UNITED STATES PATENT AND TRADEMARK OFFICE

APPLICATION NO.	FILING DATE	FIRST NAMED INVENTOR	ATTORNEY DOCKET NO.	CONFIRMATION NO.
10/619,837	07/14/2003	Gregory Pinchasik	4303-4003US6	7636

Office Action Summary	Application No. 10/619,837	Applicant(s) PINCHASIK ET AL.	
	Examiner Vy Q. Bui	Art Unit 3773

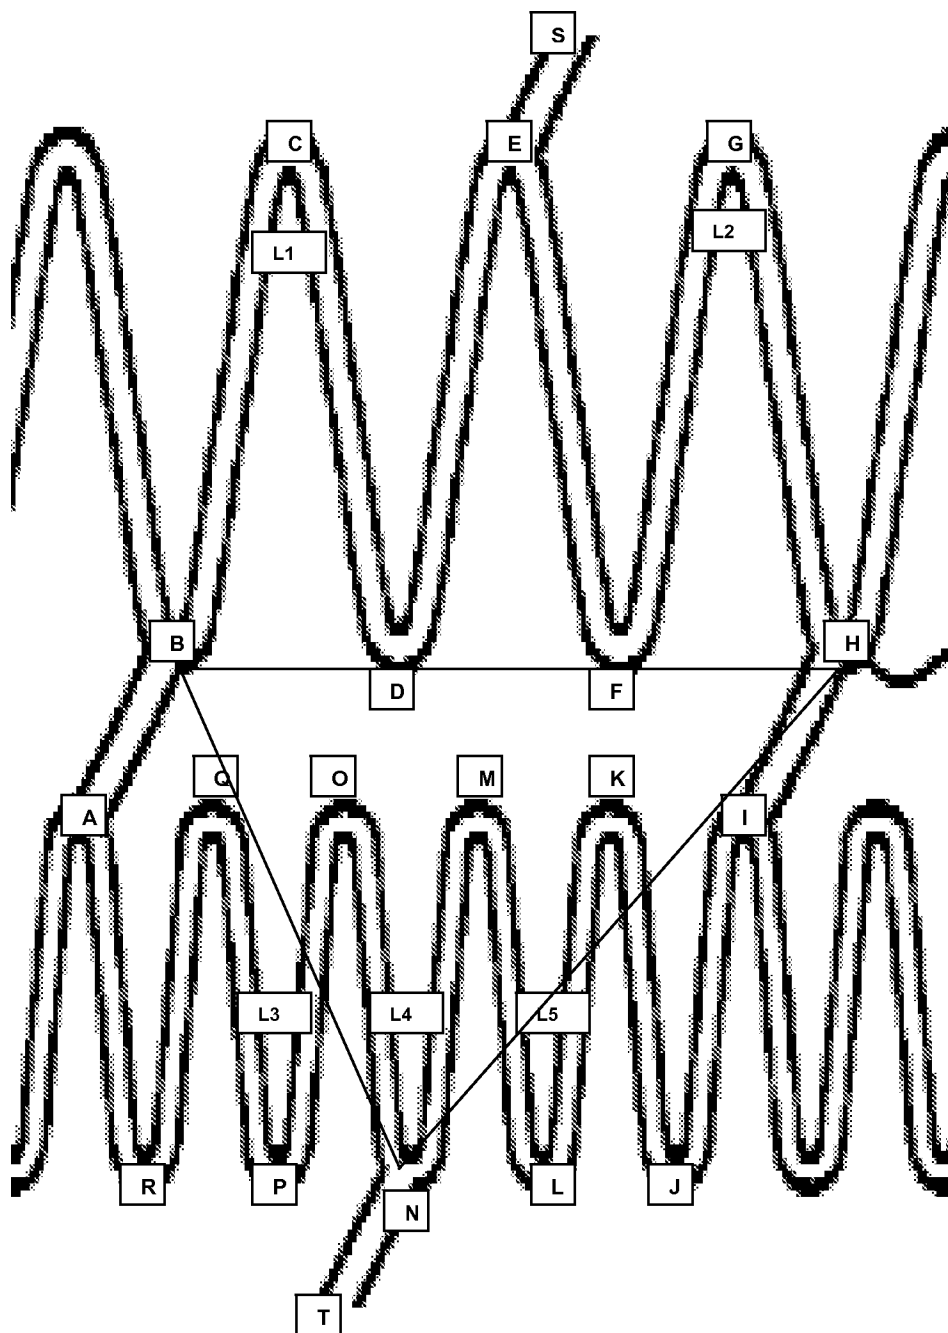
As to claims 95-103, 125-138, 140-145, 147-148 and 184-188, Brown-'848's Fig. 2 and Fig. 3 show a stent of stainless steel or Nitinol (C. 12, ll. 25-37 and enlarged one cell below) including triangular cells having wider and stronger members of lower frequency F1 (1st member ABC, 2nd member CDE, 3rd member EFG, 4th member GHI) than members of higher frequency F2 (5th member ARQP, 6th member PO, 7th member ON, 8th member NM, 9th member ML and

10th member LKJI) and 1st to 10th members formed 1st loop L1, 2nd loop L2, 3rd loop L3, 4th loop L4 and 5th loop L5 substantially as recited in the claims.

As to claim 131-132, Brown-'848's Fig. 2 shows 1st, 2nd, 3rd, 4th members wider than 5th, 6th, 7th, 8th, 9th, and 10th members.

As to claim 134, longest 2nd member CDE (joined 3rd member EFG) extends from E to S in the adjacent cell.

As to claims 144-145, 147-148, Brown-'848's Fig. 2 shows wider 1st, 2nd, 3rd, 4th members in comparison to 5th, 6th, 7th, 8th, 9th, and 10th members. Therefore, 1st, 2nd, 3rd, 4th members inherently must have greater radial compression than that of 5th, 6th, 7th, 8th, 9th, and 10th members.

Fig. 30

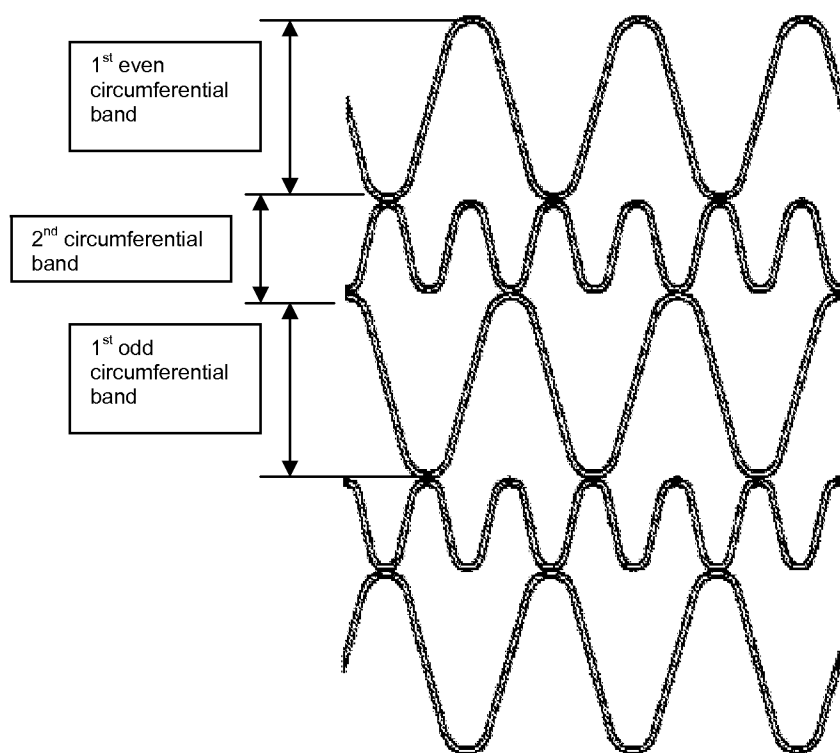
As to claim 195, Jayaraman-'245's Fig. 28 and Fig. 30 (see below) show a stent including 1st circumferential bands of lower frequency F1 and circumferential bands of higher frequency F2 substantially as recited in the claims.
